ADDENDUM NO. 1

**Administration Building Renovation Re-bid
Compton Community College District**

tBP Project. No. 20987.00

tBP/ARCHITECTURE

P-1
drawing of

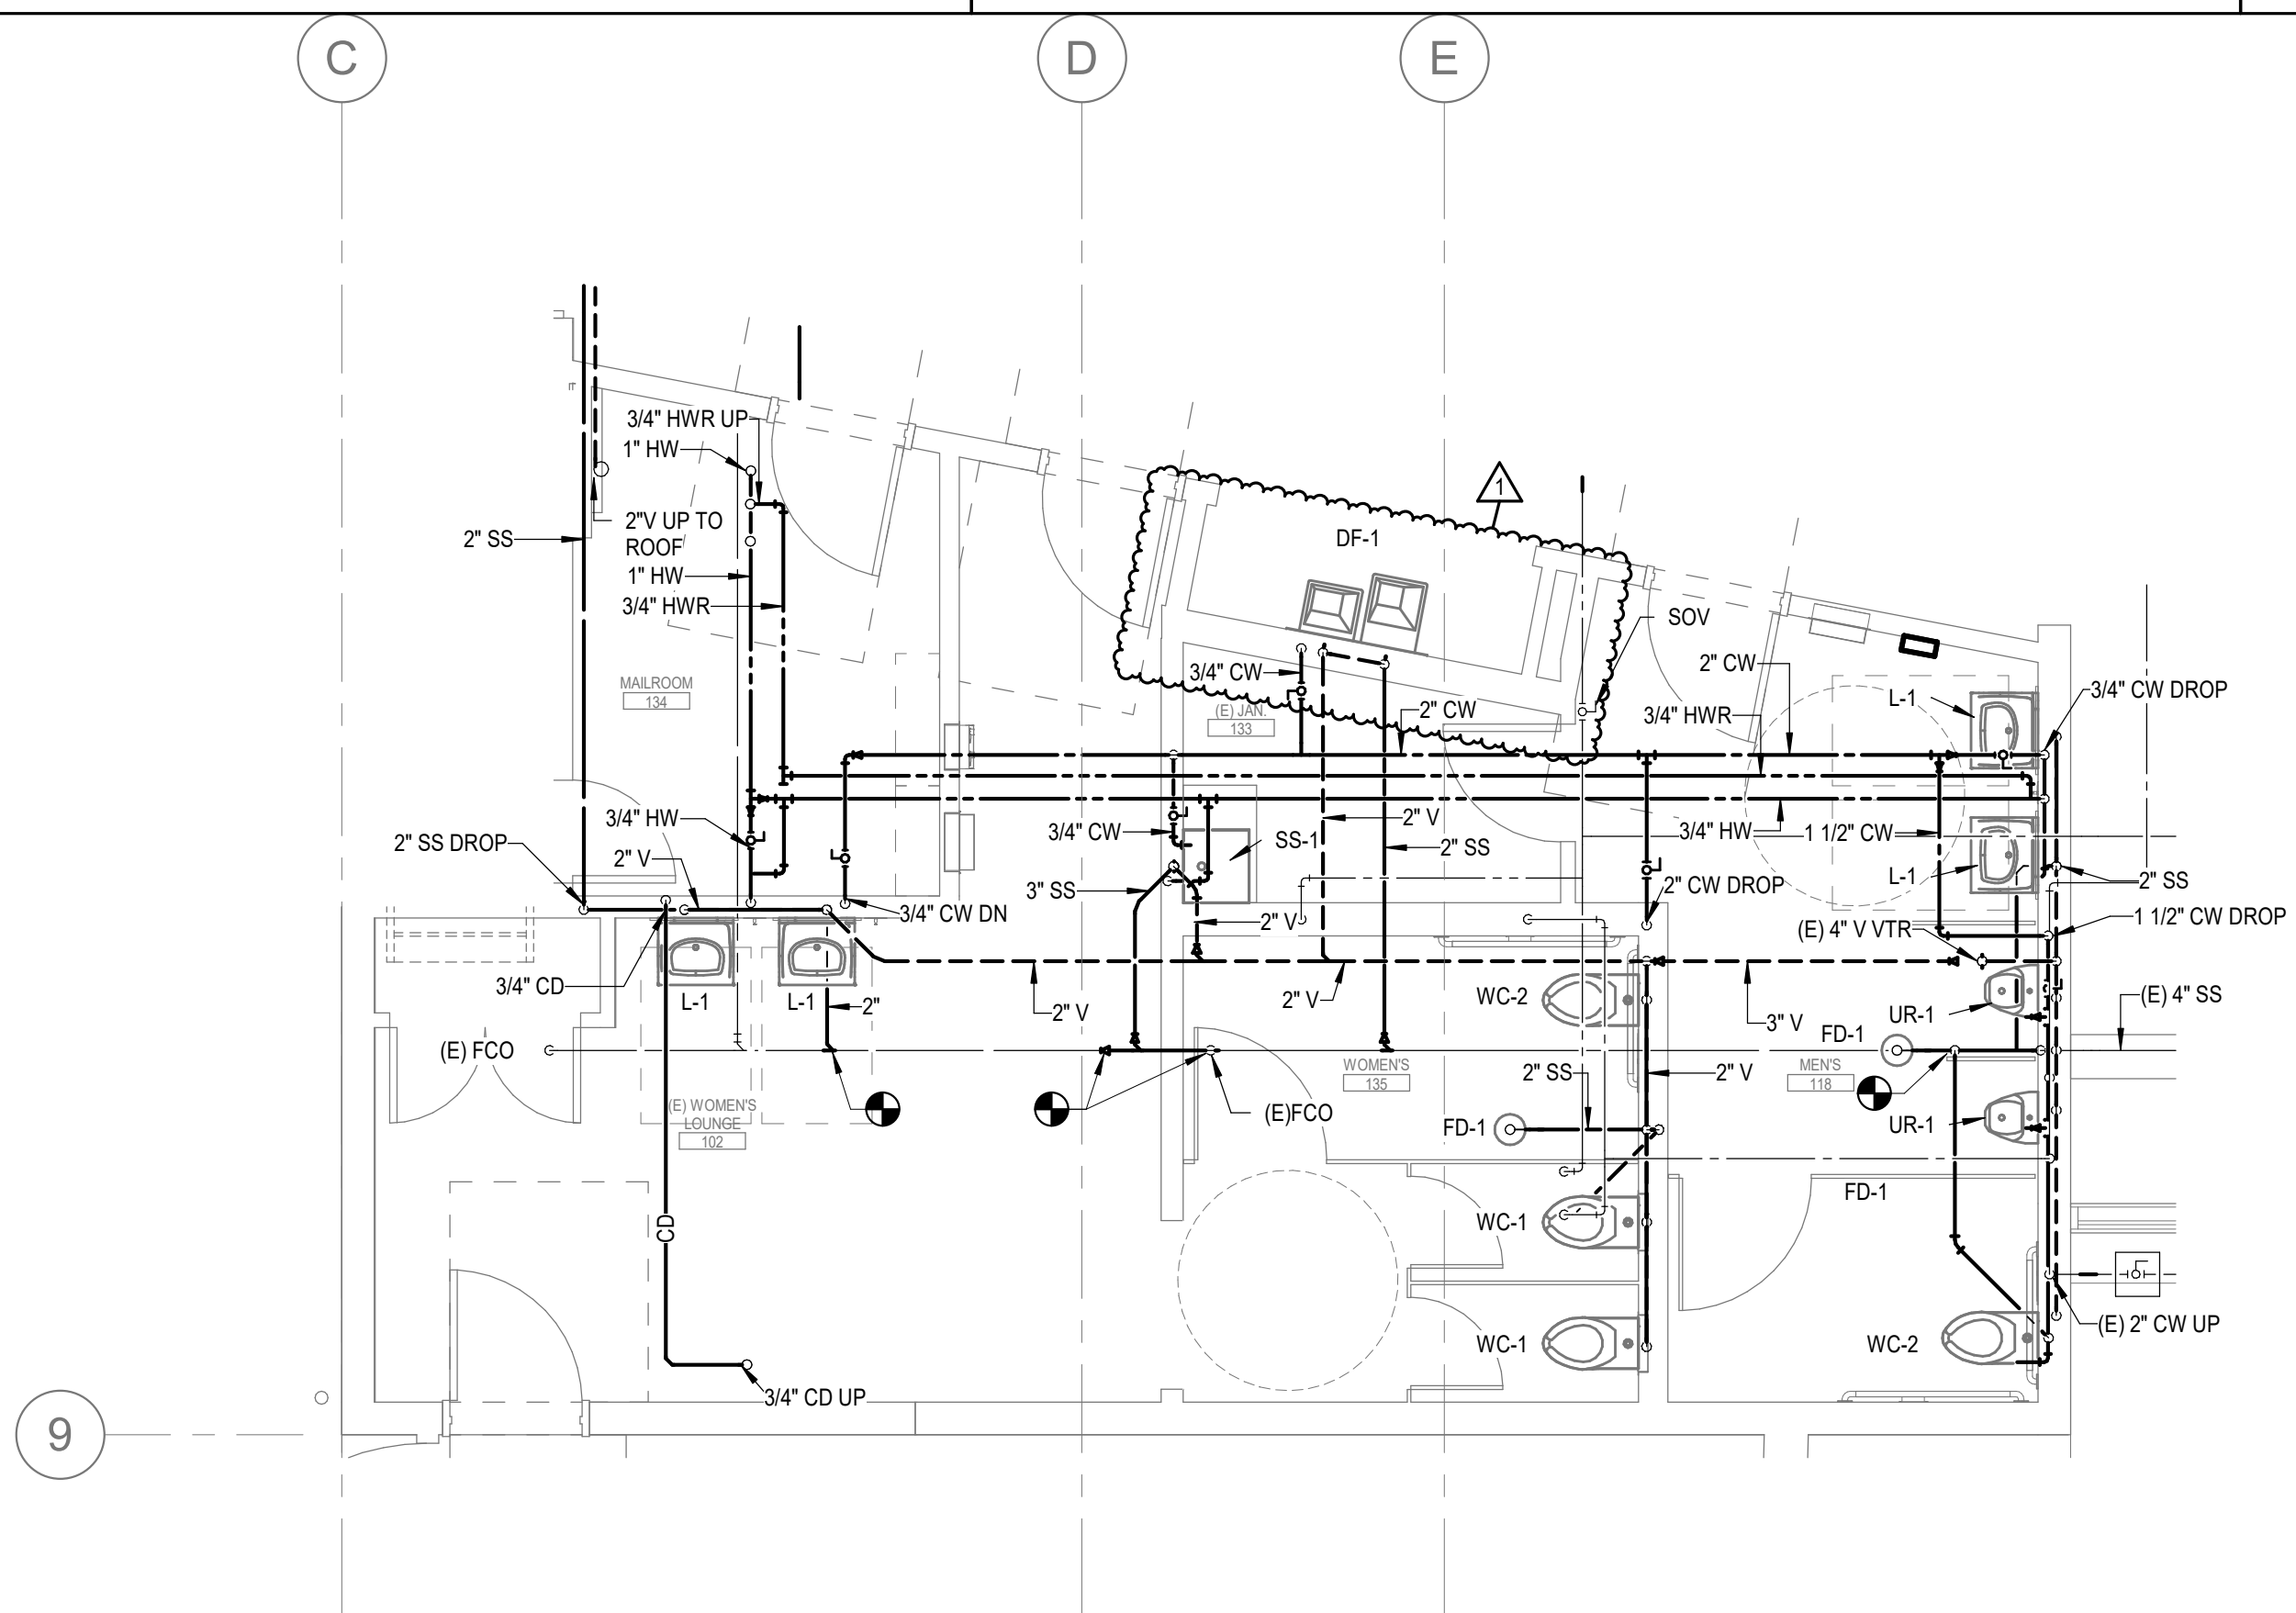
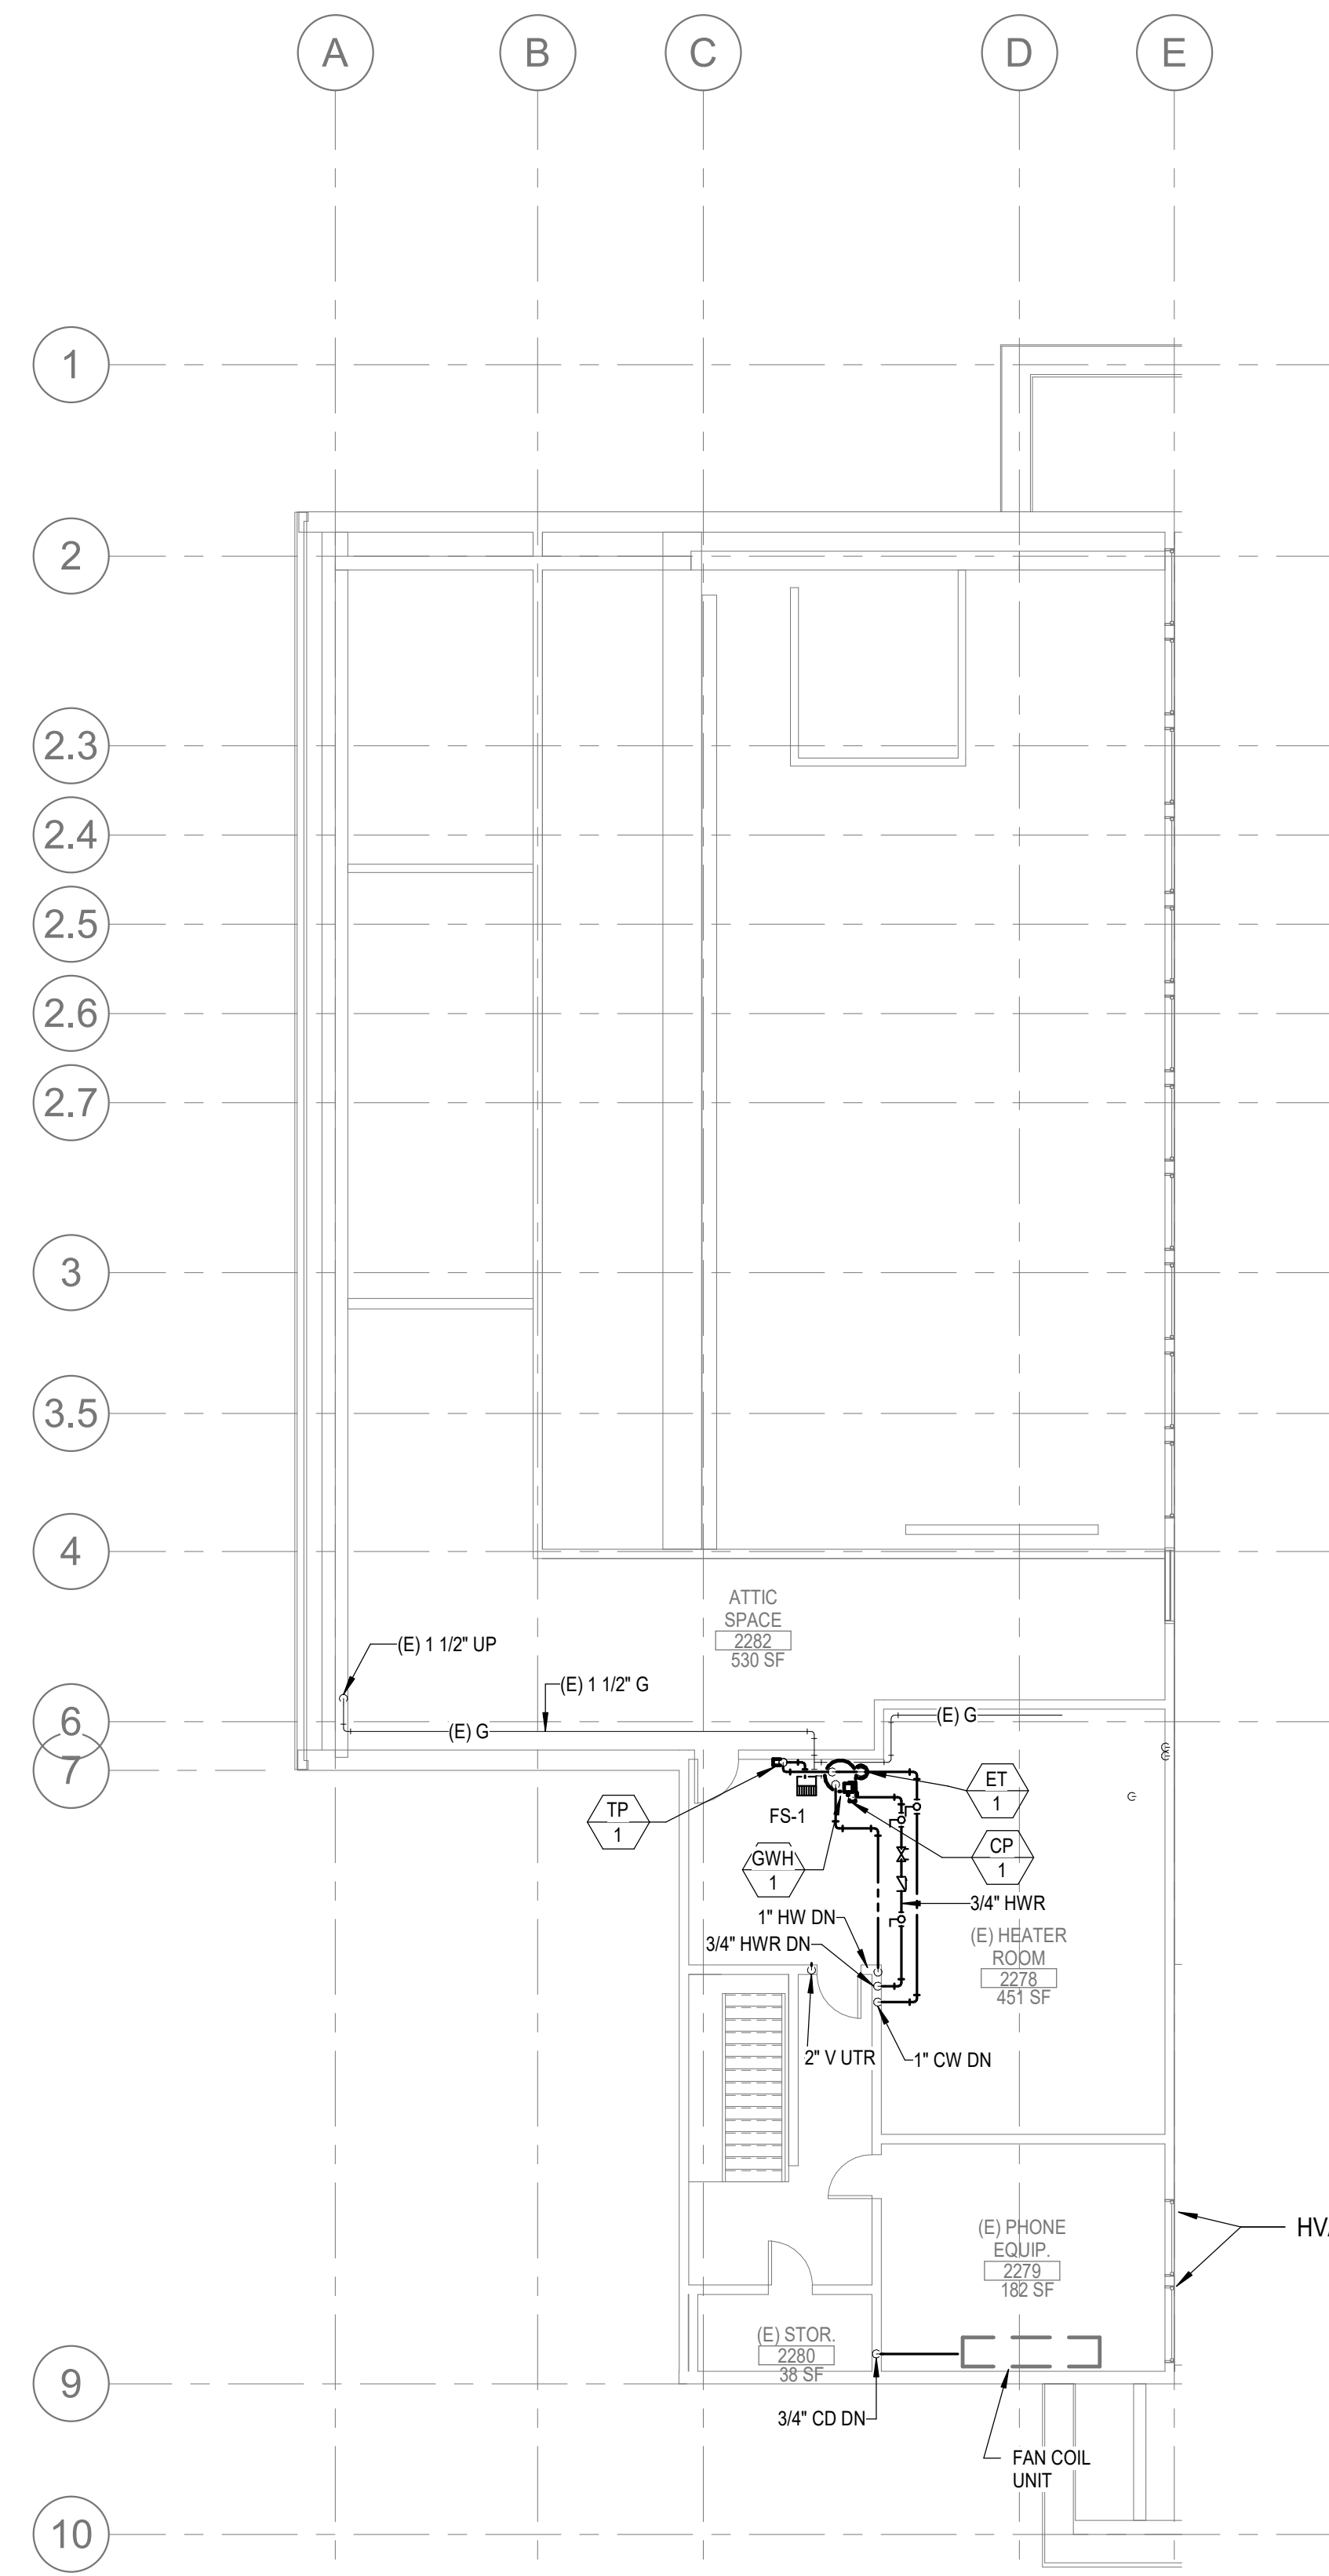
- 21 **Revised Sheet P-1 PLUMBING REMODEL FLOOR PLANS**
- a. Relocated the drinking fountain from the corridor to the vestibule location.
See attached revised Full size sheet identifying revisions included as part of this addendum.
